From: [Eli Z Tsarovsky](#)
To: [Plan Commission Comments](#)
Subject: Plan Commission - 12.12.22 - Agenda Items 6-8
Date: Monday, December 12, 2022 9:27:37 AM
Attachments: [Lake Street Garage Committee Report \(1\).pdf](#)

My name is Eli Tsarovsky and I am the President of the Campus Area Neighborhood Association. I am emailing you all today in opposition to the current plans for the 415 N Lake Street Redevelopment in the 2nd Ald. Dist.

Lake Street Garage Steering Committee Report

November 21st, 2022

Alternate Layout

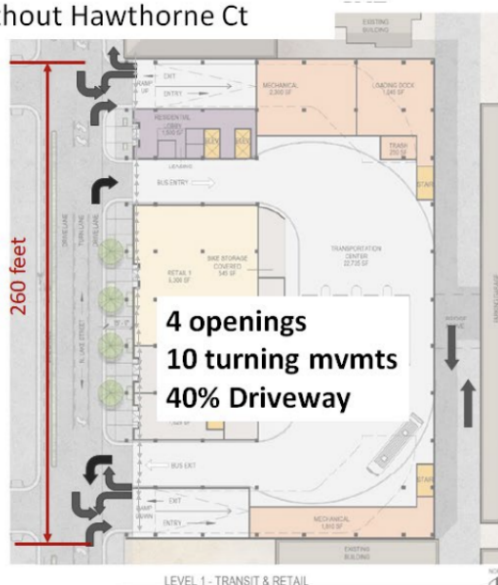
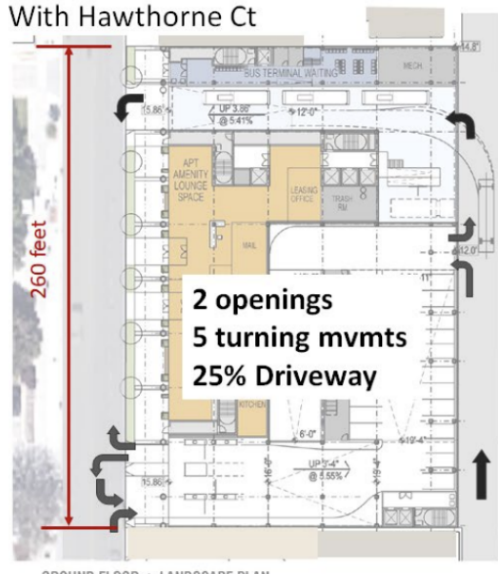
The traffic flow of the current proposal requires intercity buses to cross important, busy lanes of traffic that include **the Major BRT (Bus Rapid Transit) Lane, the unprotected Bike Lane, and the Major Sidewalk**. This is a major logistical flaw as this presents lots of opportunities for major backups on University Ave due to buses not being able to cross the lanes of traffic and a higher risk of accidents due to the Hawthorne Ct functioning as an alleyway and not being a controlled intersection. Not to mention University Ave is a much faster street than Lake Street and increases the risk of accidents like fender benders and bikers being hit during rush hour traffic. The development needs to use Lake Street for buses because it is a controlled intersection with a stoplight as compared to the Hawthorne Ct entrance which has no traffic signals. Additionally, the East Campus Mall BRT Spot can be inferred as a major bus stop for students commuting across campus. The three major residence halls are within a couple of blocks of this spot. Blockages at the Hawthorne Ct entrance will disrupt this major BRT system hub.

The three spots for buses seem inadequate and are shortchanging the intercity bus station potential. The bus terminal ought to have five bays like the old bus terminal and there needs to be a better plan for staging. They are trying to do too much at once and seem to be modeled after La Crosse without consideration of the unique challenges of this area. The Bus terminal is different and you can drive straight through it. This design

seems too complex at the moment. The proposal does not seem to completely address everything. The entrances for residential parking are on the same side as the Van Galder Bus entrance. This mix of traffic seems problematic with bus schedules and the residential experience. If there is a queue that wraps around the corner, this will affect the BRT lane and Metro Bus lane. There is also a need for more entrances and exits to accommodate queues during special events.

- Moving the entrances to the bus terminal and parking to Lake Street
- Creating a Transportation plan that considers all modes of transportation on the site
- Using this project to activate Hawthorne Court with public art, lighting, and cameras
- Make the bus terminal part of a covered part of Lake Street.
- We need a complete Traffic/Environmental Study that considers the impact on local businesses, existing apartments, and all current modes of traffic circulating through this site.
